CITY OF OREGON CITY

AGENDA

PD 03-02

REQUEST: The applicant is requesting approval of a Planned Unit Development.

Existing Conditions

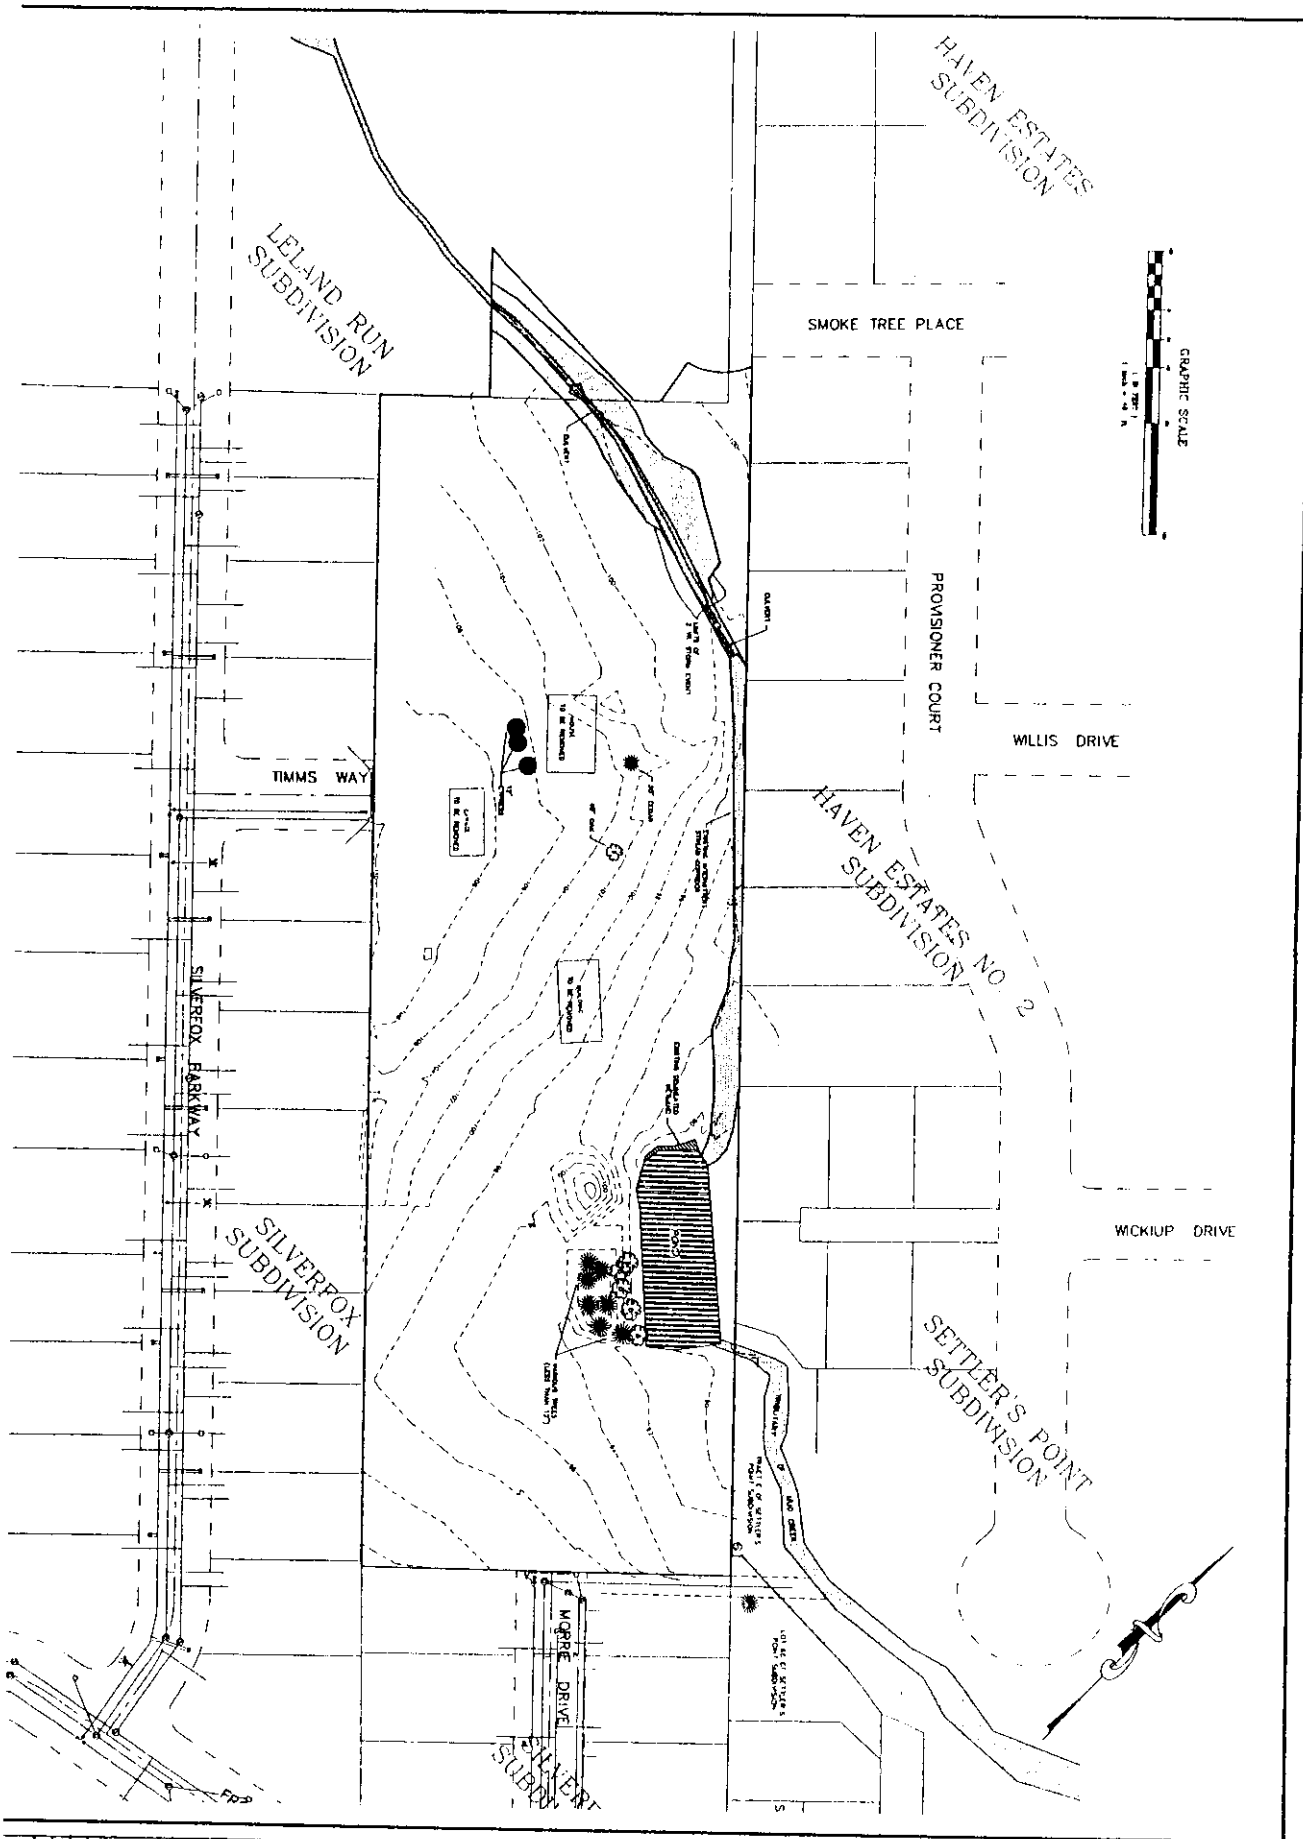
Finding: The applicant provided an existing condition plan that identifies 3 trees to be removed from the site. It is unclear if the proposed trees to be removed are within the building envelopes on the lots.

The applicant shall provide a revised landscaping plan demonstrating the relation of the trees to the proposed setbacks of the lots on which that are located and the replacement location of all trees removed from the site that are not located within the building footprints (setbacks) of each lot prior to the issuance of a grading permit for the site. The applicant shall have a qualified consulting arborist or horticulturist prepare a site preparation and management program to provide protection to the trees not designated for removal on the landscaping plan to avoid disturbance to tree roots from grading activities and to protect trees and other significant vegetation identified for retention from harm.

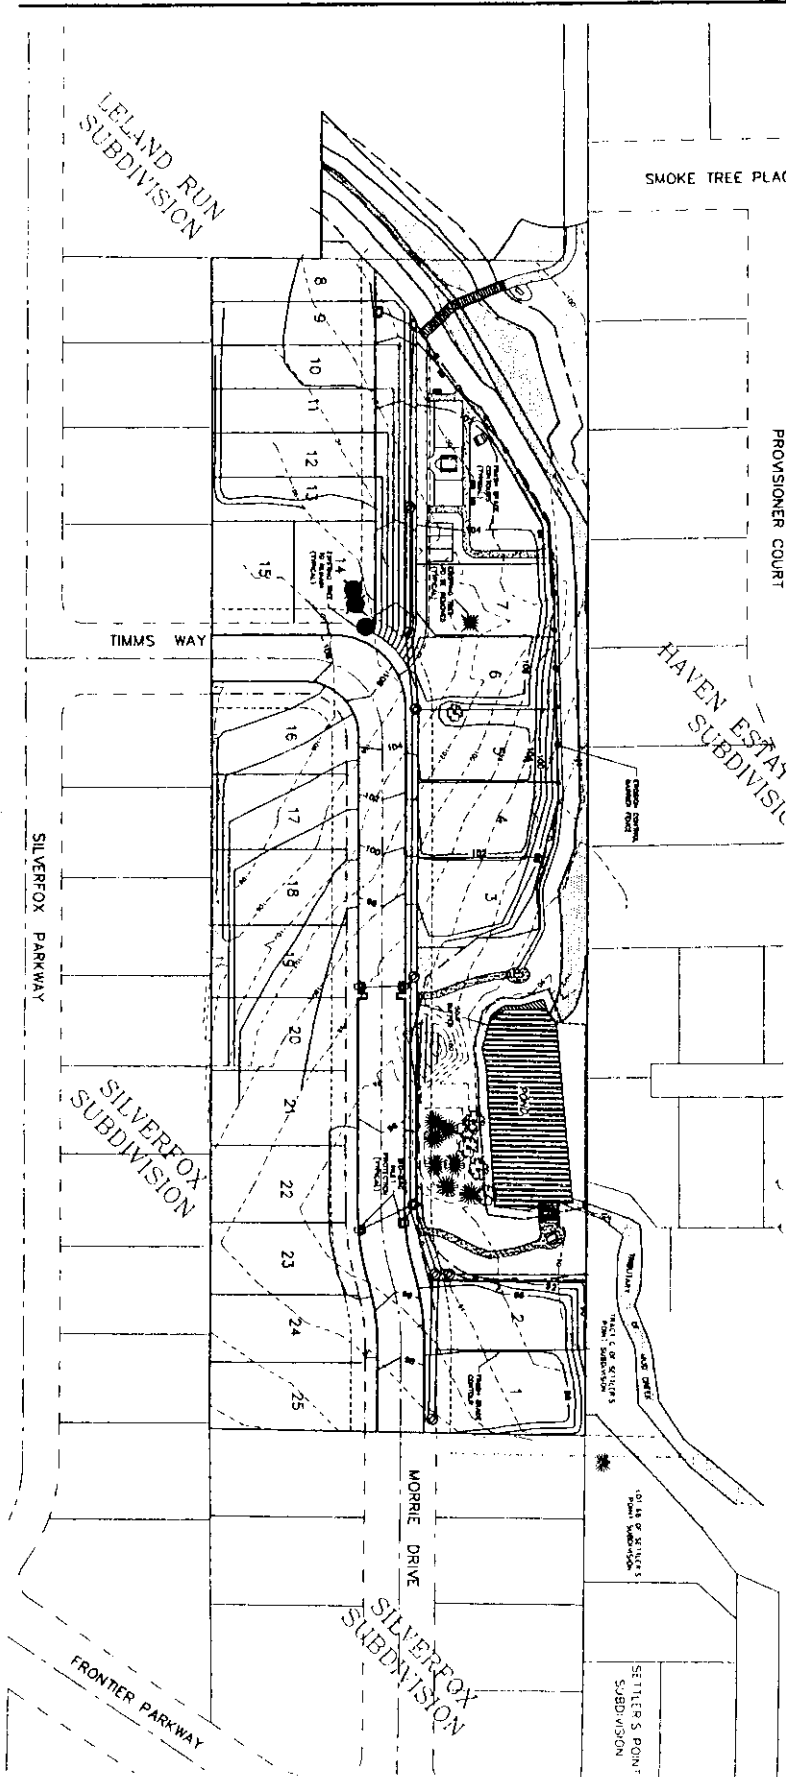
Finding: The applicant provided a preliminary Grading and Erosion Control plan. A final site grading plan shall be required as part of the final construction plans per the City Residential Lot Grading Criteria and the uniform Building Code.

landscape plan

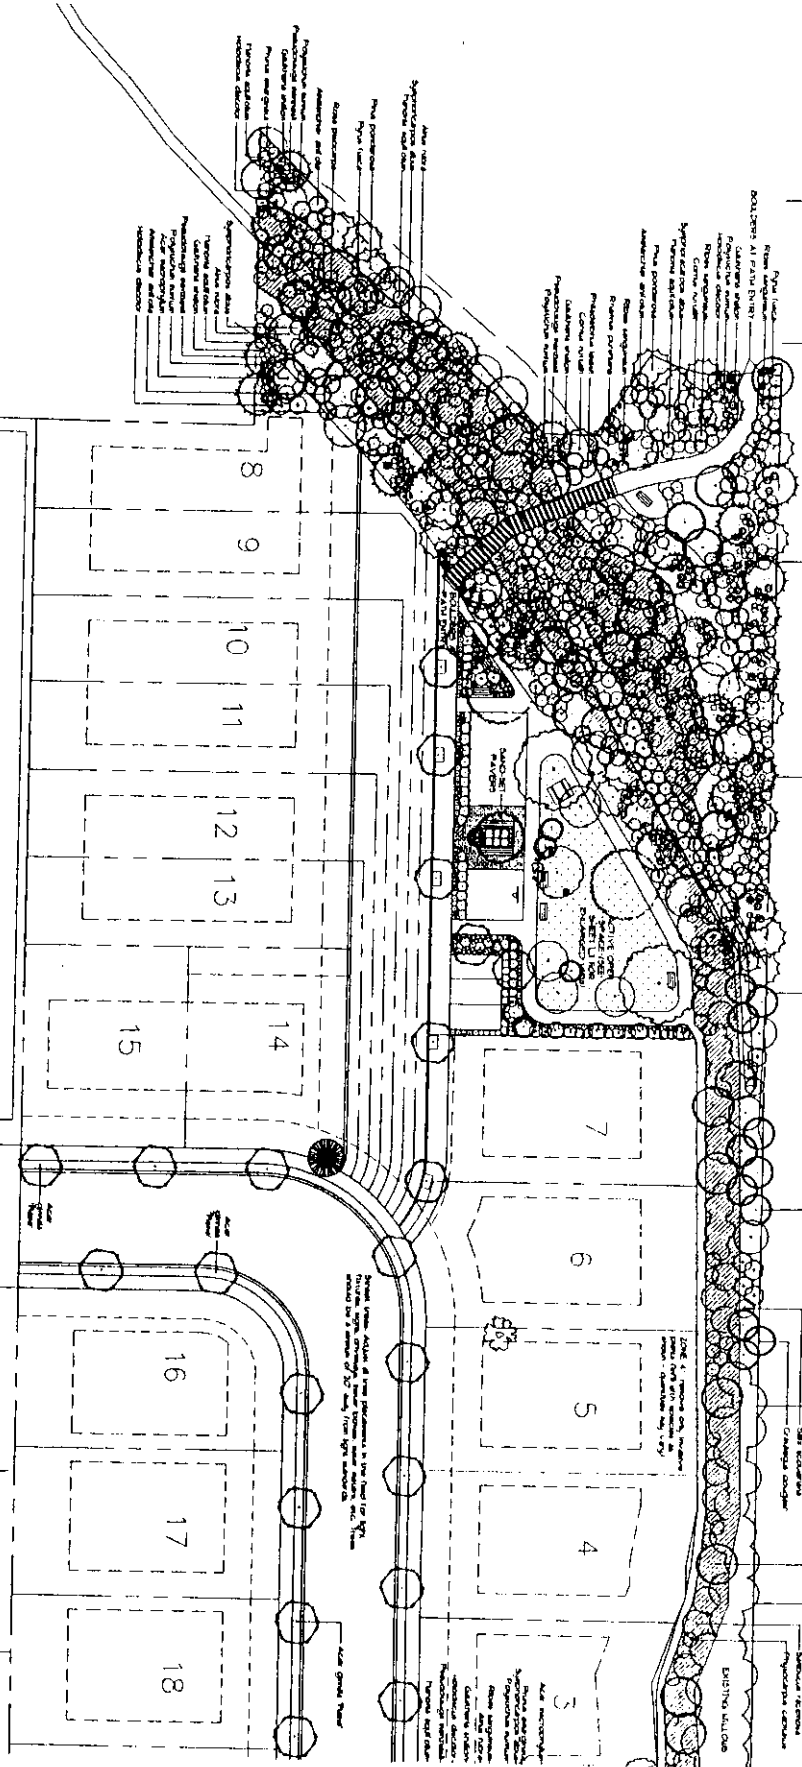
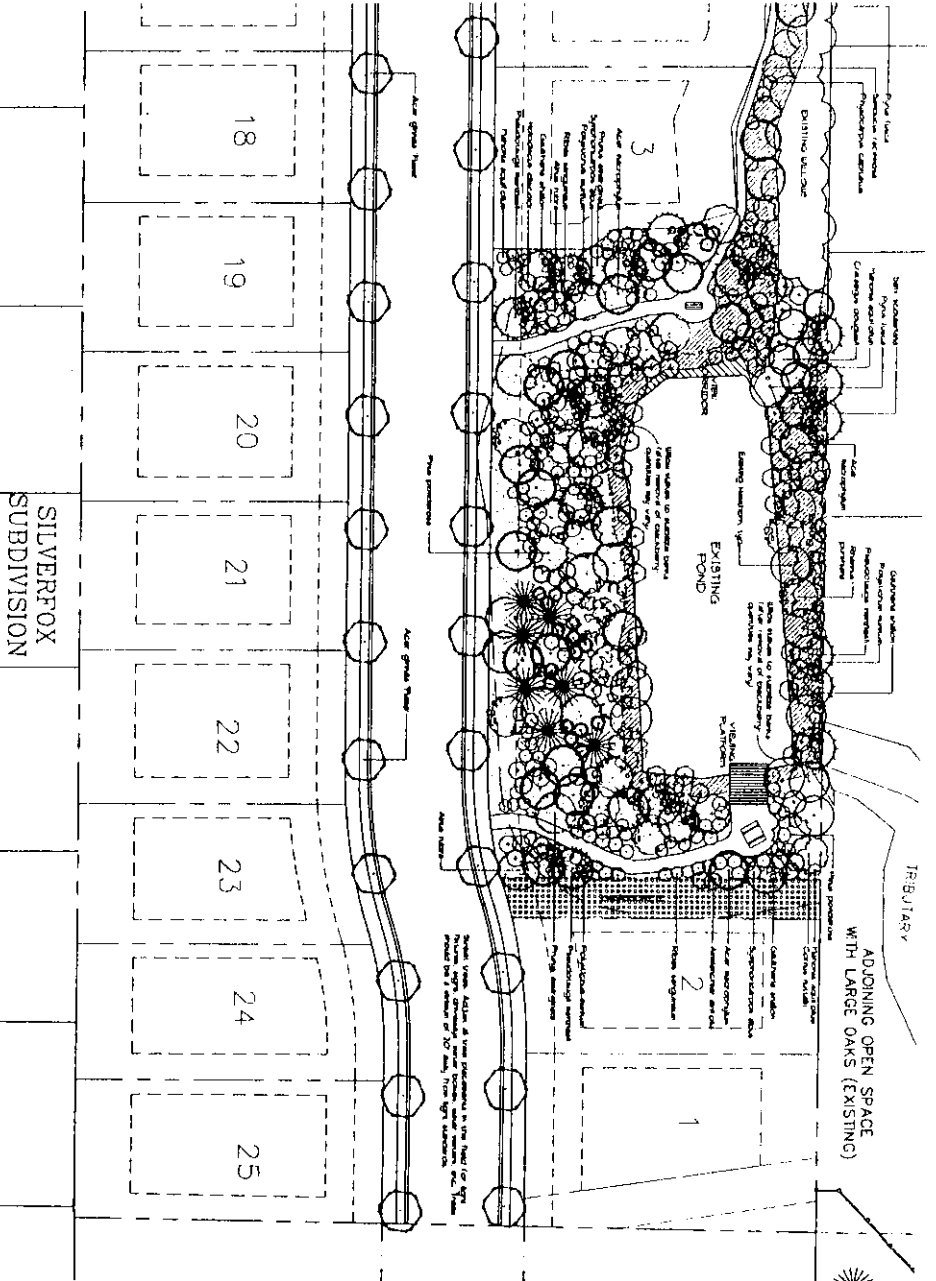
Some of the street trees proposed within the development, specifically along the private drive, are in excess of 40 feet apart. OCMC 12.08.020.A requires that street trees be planted a maximum of forty feet on center for the length of the lot frontage.
